SUBJECT: EMERGENCY PREPAREDNESS MEETING

This letter and enclosures summarize the March 15, 1996, management meeting held at our request among Mr. M. Slobodien and members of your staff, and members of the NRC Region I staff, in King of Prussia, Pennsylvania. The purpose of the meeting was to discuss the bases for the protective action recommendation (PAR) methodology currently in place for the Three Mile Island and Oyster Creek nuclear power facilities. Enclosed are a copy of the meeting notice, a list of attendees, and a copy of the handout provided by your staff.

Purpose: Management Meeting to discuss the bases for the protective action recommendation logic diagram and methodology for implementation at Three Mile Island and Oyster Creek.

ENCLOSURE 3
TMI PAR LOGIC DIAGRAM

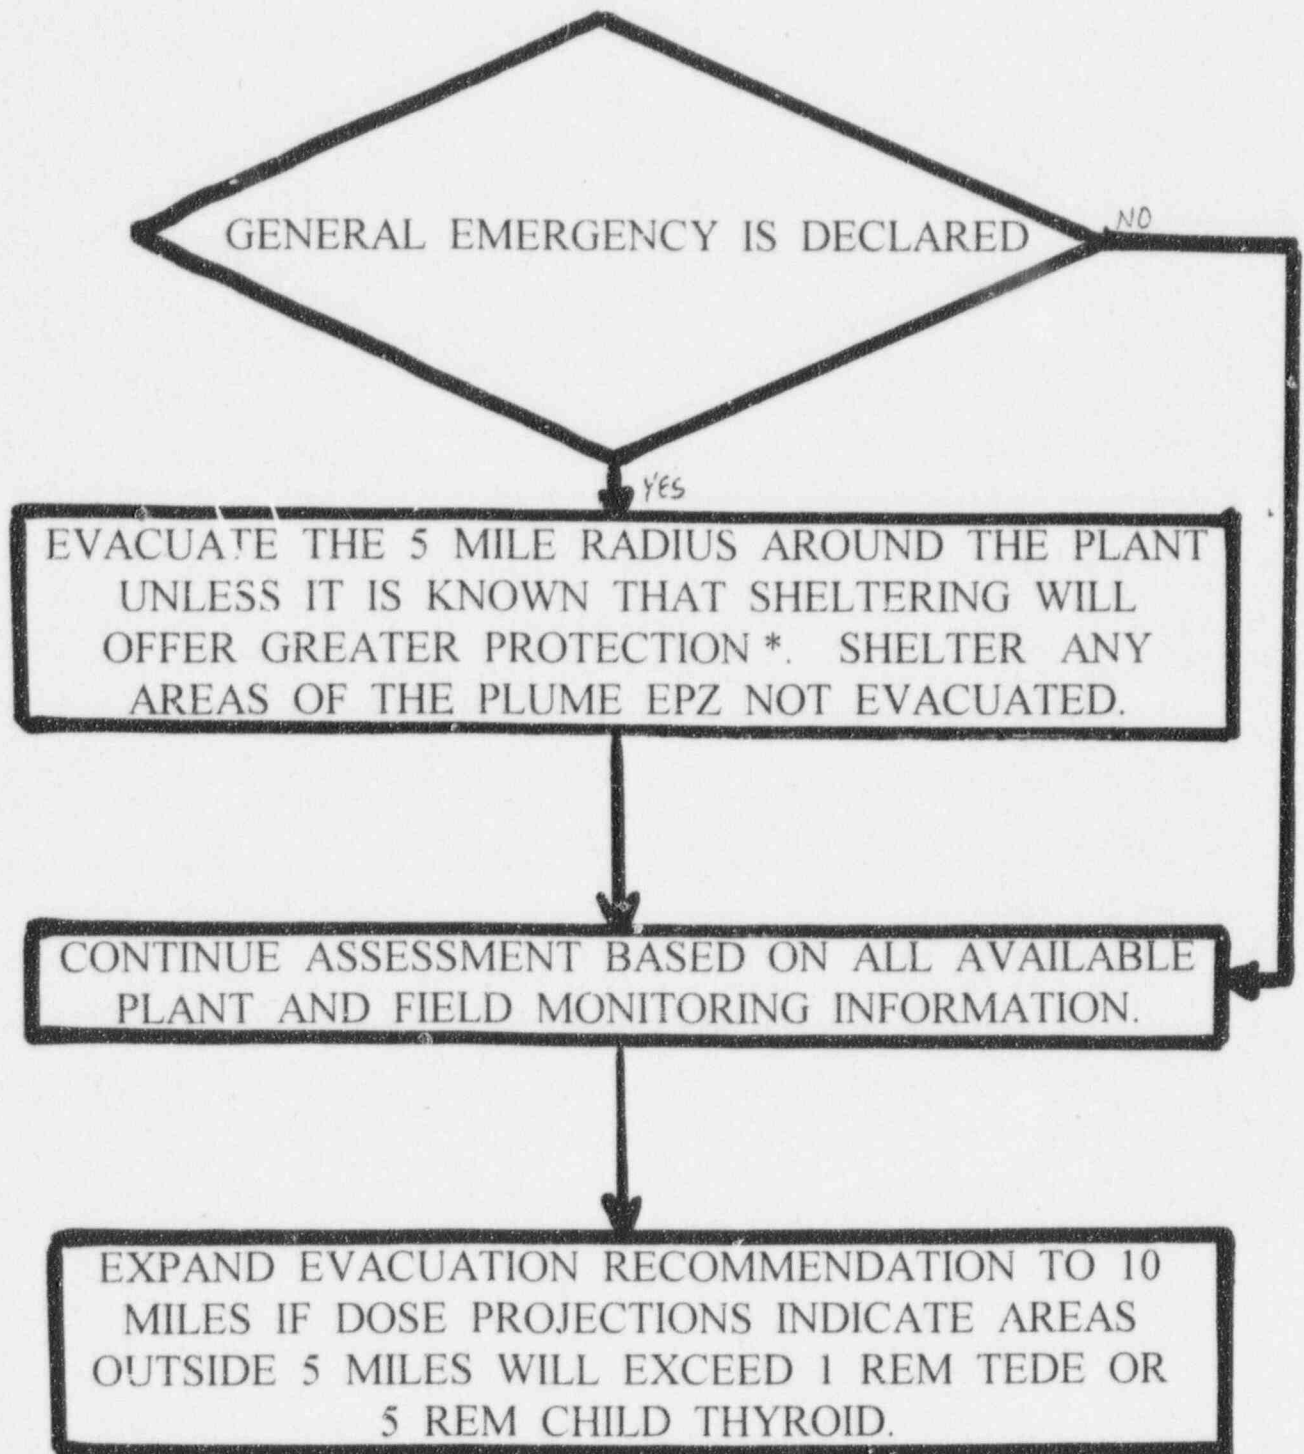
* The decision to recommend sheltering rather than evacuation should be made only when it is clear that sheltering will result in less dose to the public (For example, if it is KNOWN that the release will be terminated within 2 hours of the declaration.)

NRC PAR ADVANTAGES

- **EASIER TO USE**
- **FASTER**

GPUN PAR DISADVANTAGES

- **MORE COMPLEX**
- **GREATER CHANCE FOR ERROR**
- **RELIES ON ACCURATE EVACUATION TIME ESTIMATES**

REALITY

- **WE MAY NOT BE ABLE TO PRECISELY ESTIMATE
TERMINATION TIME**
- **ALMOST ALWAYS ARRIVE AT THE SAME ANSWER**
- **VERY UNLIKELY TO HAVE A SHELTERING SITUATION**
- **NOT WORTH DOING THE "FINE-TUNING"**

As a result of the meeting, we understand that you will revise your current PAR methodology, and logic diagrams, to be consistent with recently revised federal guidance. We also understand that you will discuss, in detail, the new PAR methodology and, in particular, Emergency Action Levels, with the affected states in the near future.

OYSTER CREEK PAR LOGIC DIAGRAM

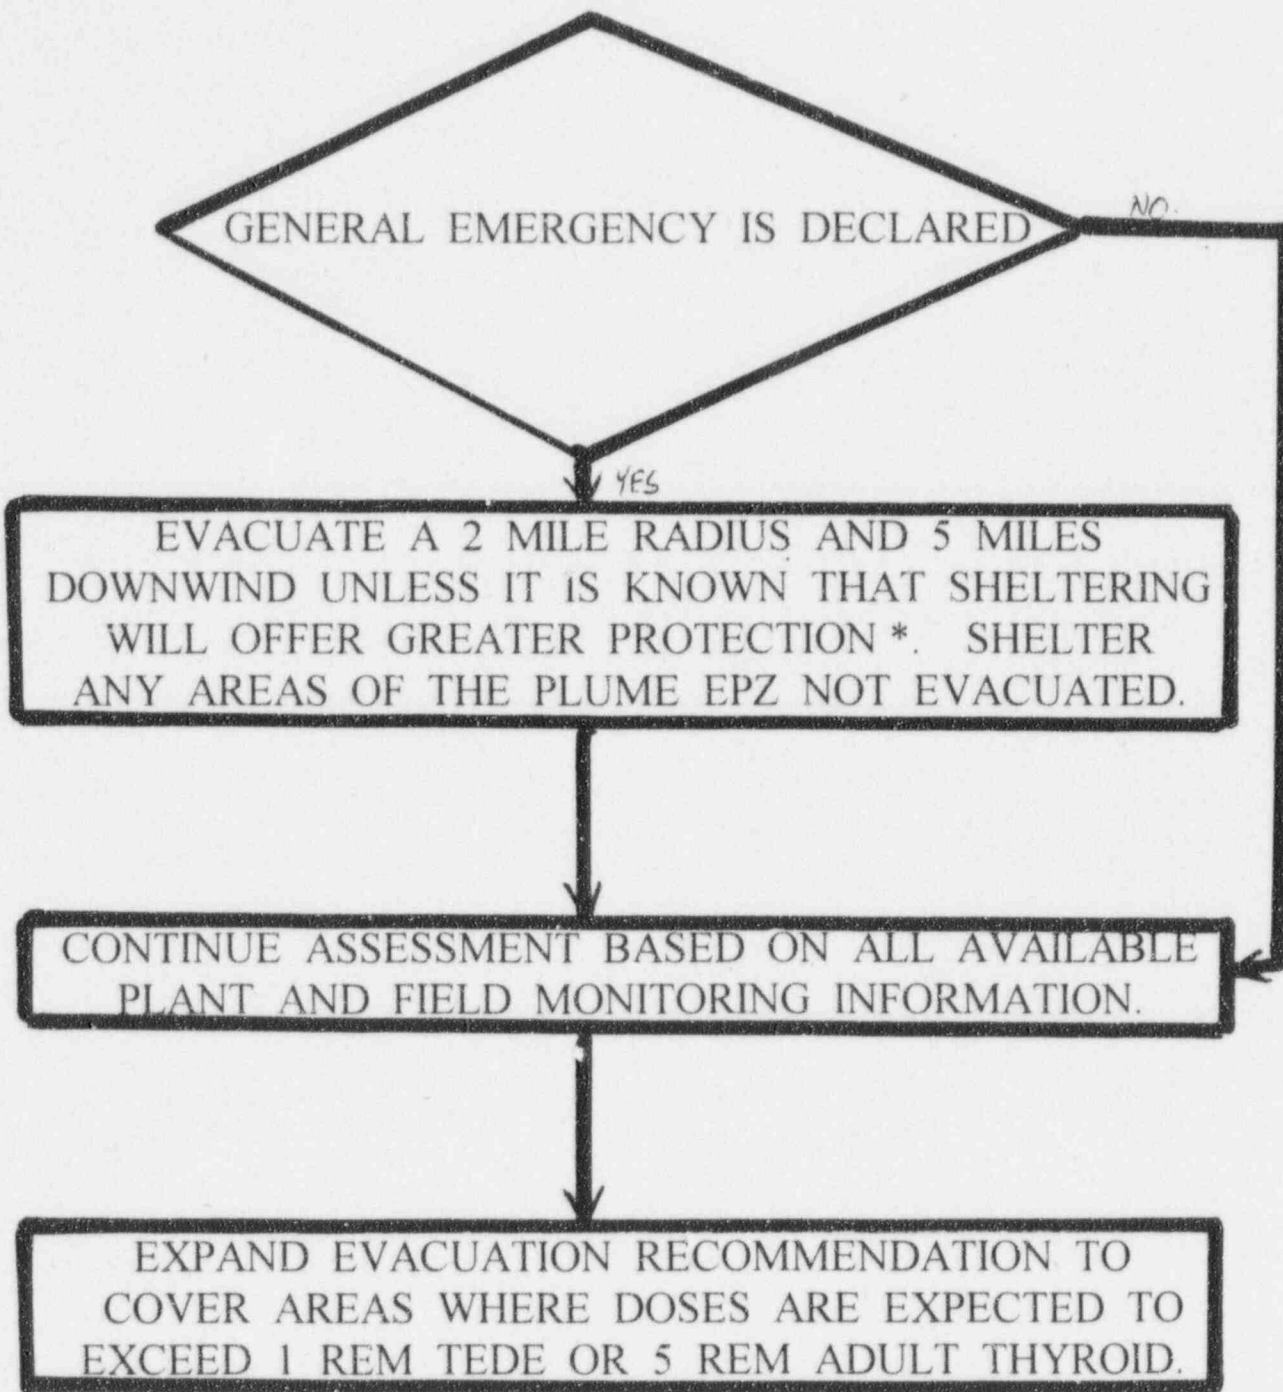
* The decision to recommend sheltering rather than evacuation should be made only when it is clear that sheltering will result in less dose to the public (For example, if it is KNOWN that the release will be terminated within 2 hours of the declaration.)
